U.S. Department of Energy
Office of River Protection

07-WTP-189

THE U.S. DEPARTMENT OF ENERGY (DOE), OFFICE OF RIVER PROTECTION (ORP)
STATUS OF STRUCTURAL STEEL FIRE PROTECTION AT THE WASTE TREATMENT
AND IMMOBILIZATION PLANT (WTP)

24590-WTP-DC-ST-01-001, Rev. 12
Structural Design Criteria
4.19, Fire Resistant Design of Structures

Figure 3 Fire Resistant Floor and Roof Systems

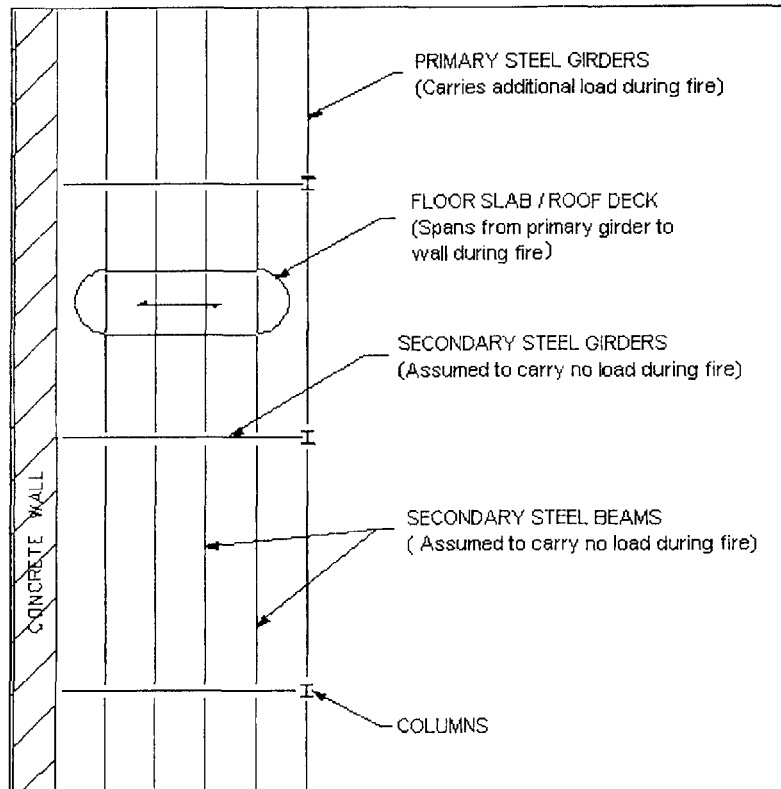
The WTP strategy is to provide fire protection for selected structural steel members based on their role in supporting the structure during and after a fire. In Reference 1, the Defense Nuclear Facilities Safety Board (DNFSB) stated this methodology would be acceptable provided it can be reasonably shown that unprotected structural members with reduced material properties due to a fire would not be relied upon to support the building. In addition, Reference 3 noted that the WTP Contractor is expected to develop a technically sound methodology for identifying structural steel members that do not require fireproof coating; and structural analyses should support the conclusion that such a structural steel member could fail without impacting the structure or adjacent safety systems.

Building stability, individual column stability and strength shall be ensured during fire events. This stability evaluation shall account for longer unbraced column lengths due to the loss of non-fireproofed secondary beams, girders, and diagonal bracings that are postulated to no longer provide lateral support to the columns. The design demand of columns shall be evaluated for higher loads caused by the loss of fire-degraded vertical-load members (bracing that carries vertical load) that are non-fireproofed and postulated to be inactive in the structural path. It is not required to consider fire events in multiple fire areas for the strength and stability evaluations.

- **Floor Slabs** are concrete floor slabs that span between walls and Primary girders during fire events, and span between steel beams and girders for normal loading. Following are the additional load combinations, enveloping ASCE-7 fire load combinations.

- **Secondary Steel Girders and Beams** are non-fireproofed girders and beams that are assumed to have zero strength during fire events. These members span between Primary girders and concrete walls, they support floor slabs and provide lateral support to columns for normal operating plant conditions and seismic events. No additional load combinations are required.

Roof decks are classified as fire barriers or non-fire barriers depending upon the facility's building code classification. Roof structures that are fire barriers, shall be designed and supported similar to floor slabs for fire events. Roof structures that are non-fire barriers do not require fireproofing. However, these roof structures shall be designed to allow the non-fireproofed members in a fire area to be rendered ineffective without causing collapse of the remaining structure.

Primary Roof Girders are fireproofed steel girders that frame into Primary columns and support roof decks during fire events, they are evaluated the same as **Primary Steel Girders**.
